VIPER 990

NEW OPTIONALS BODYMOUNT CARBON SET S9XX #903845

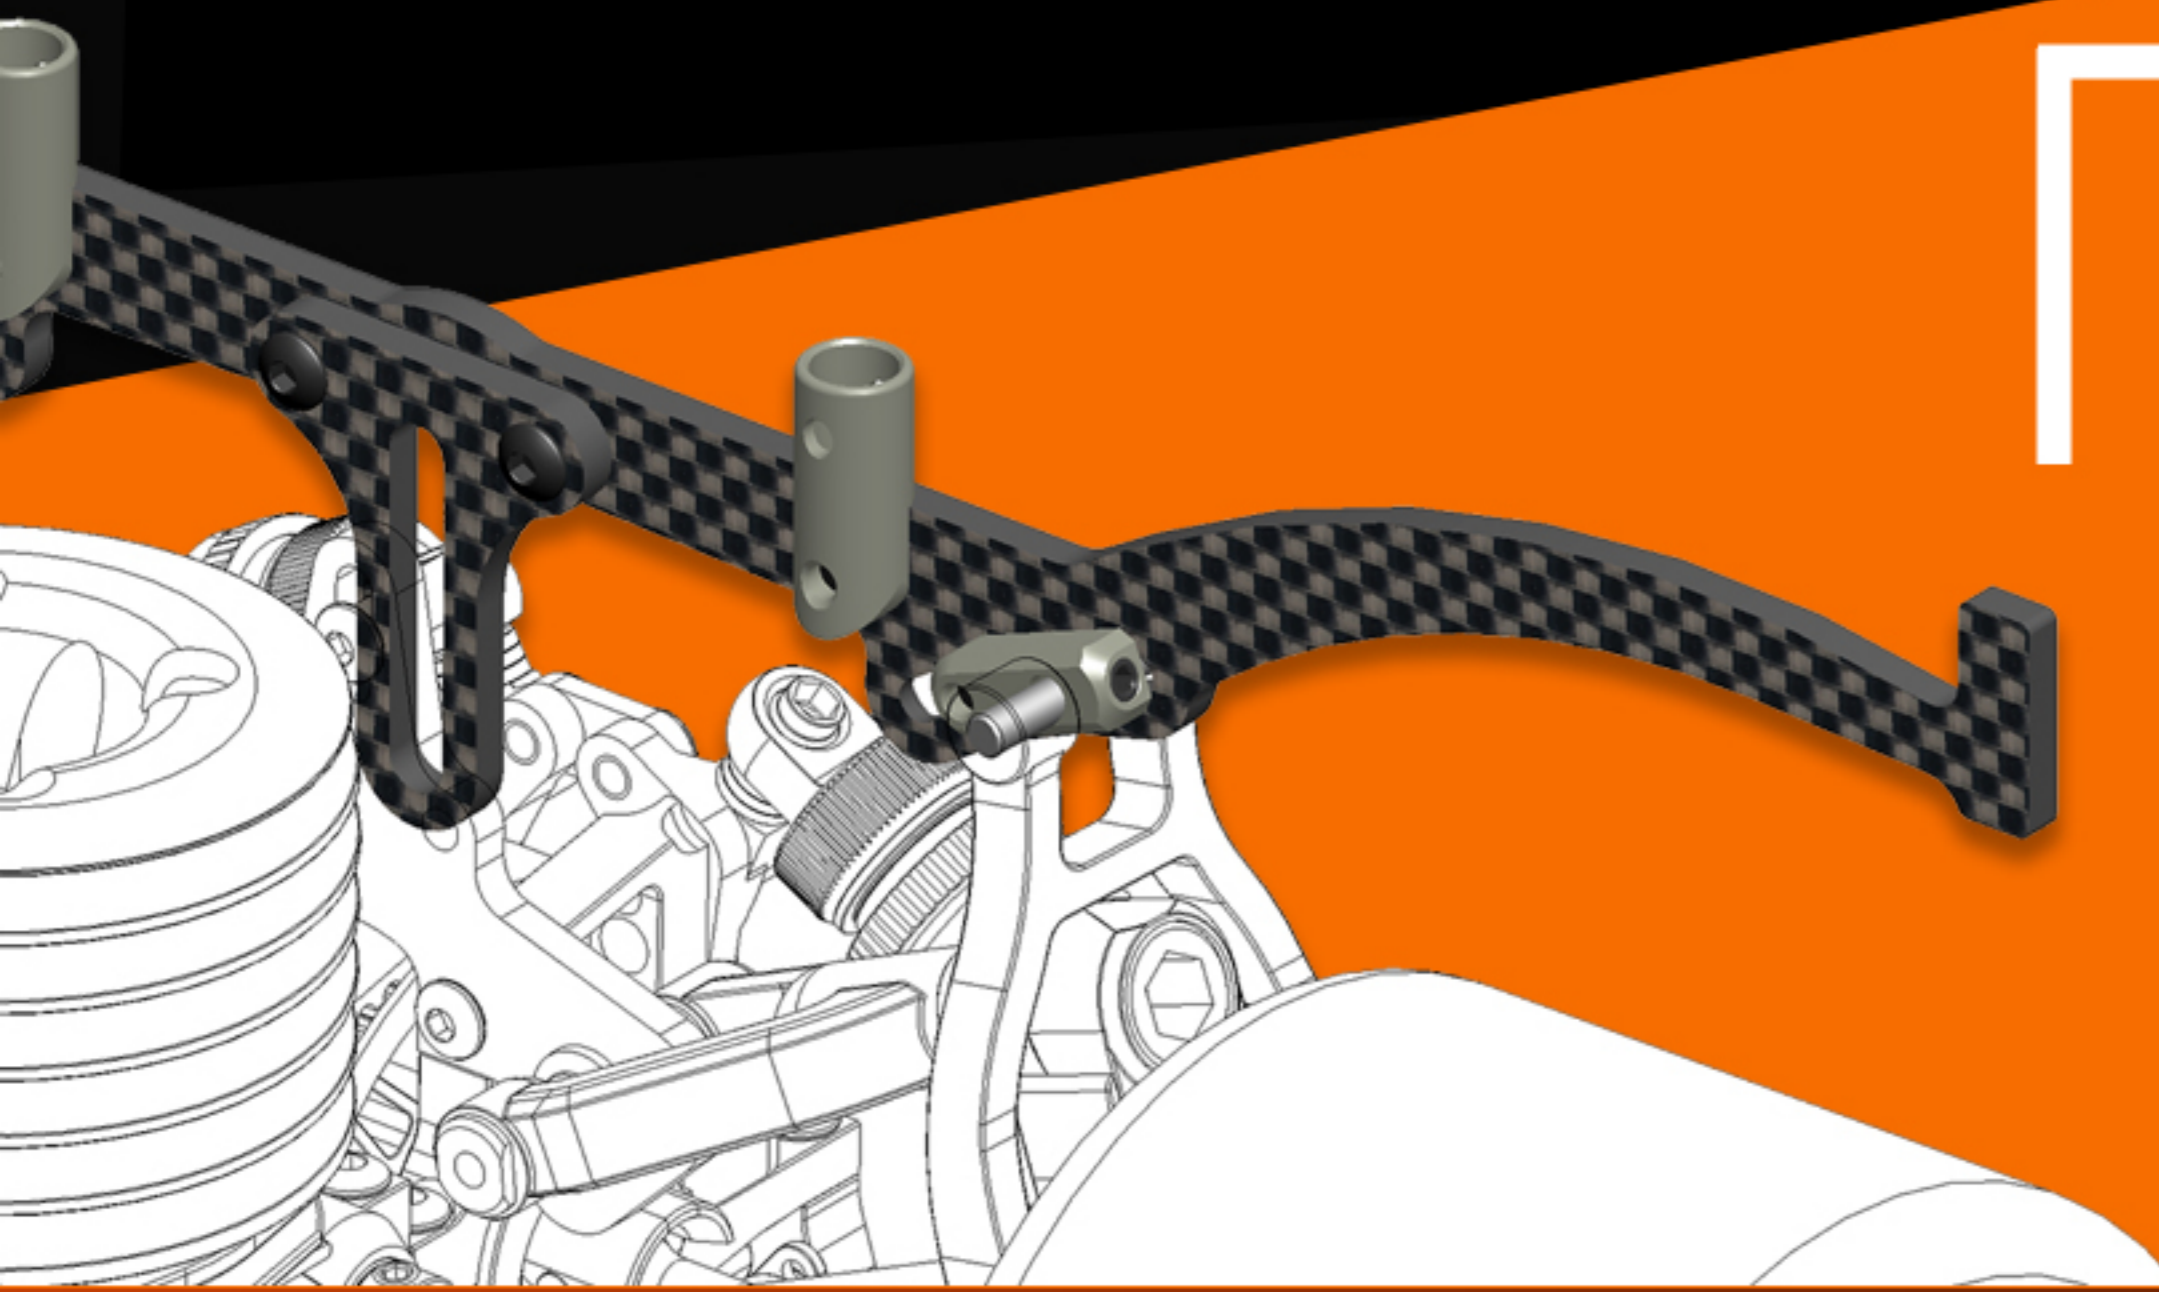
The new optional carbon bodymount is a much lighter version.

It provides excellent support for all Xtreme bodysHELLS. The total weight is 21g, which saves 14g compared to the standard bodymount.

The upper pin is securely fixed by an M3 setscrew which can be properly tightened in the hard anodized aluminium adapter.

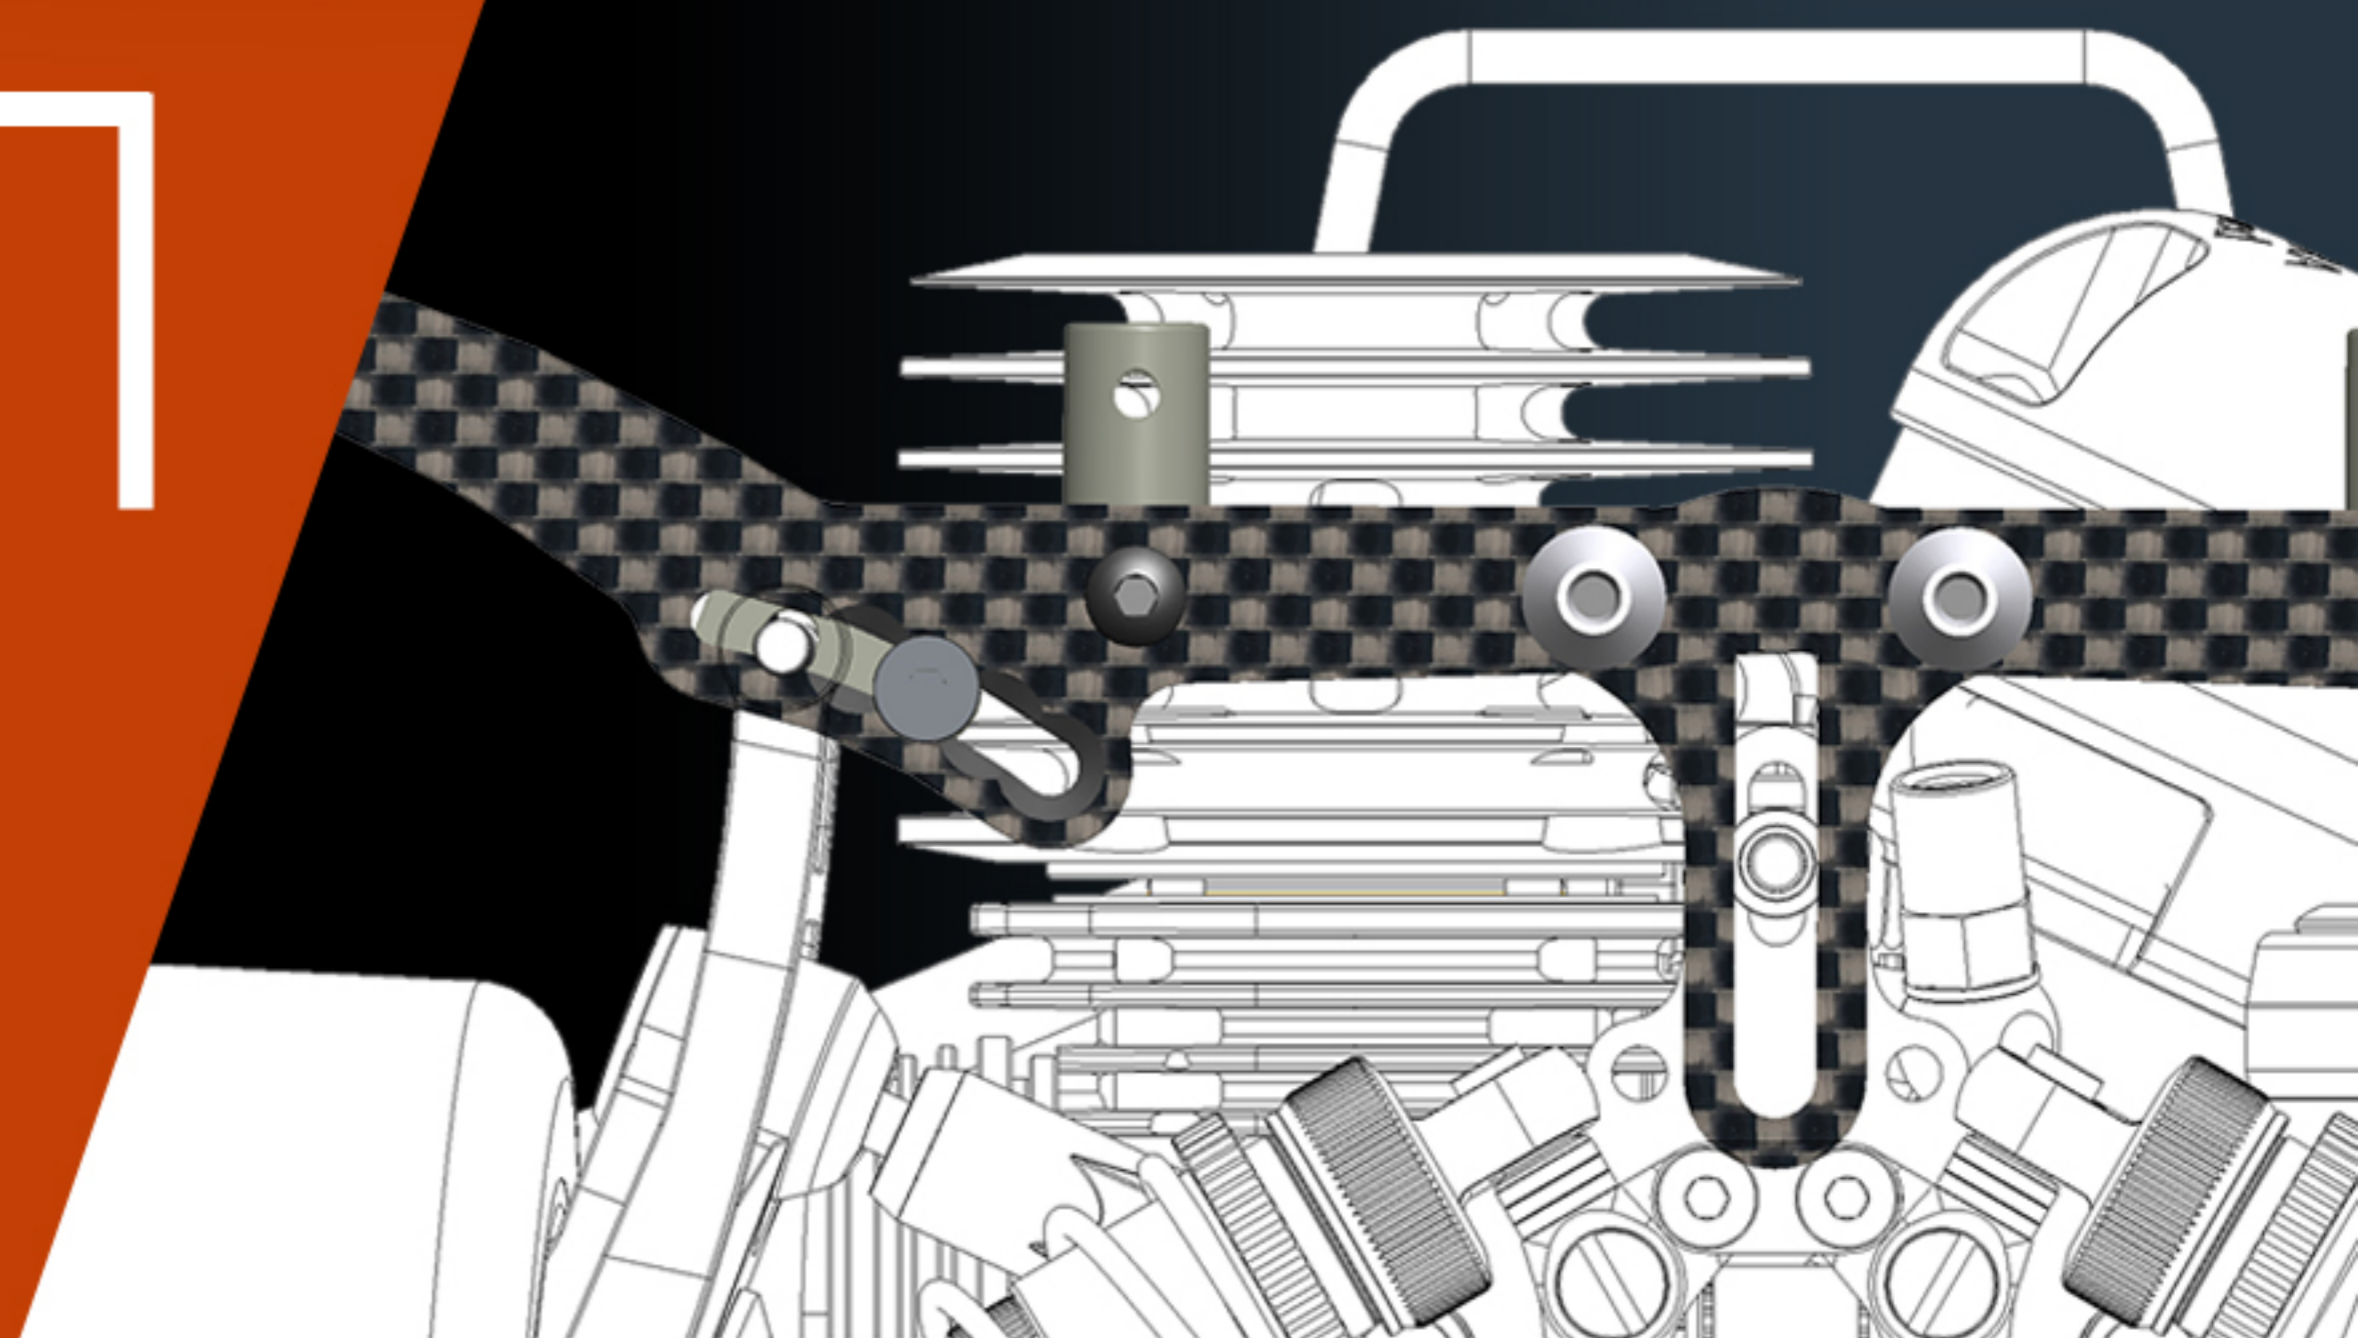
The upper hinge **position** can be adjusted "on the fly" without even take off the bodysHELL
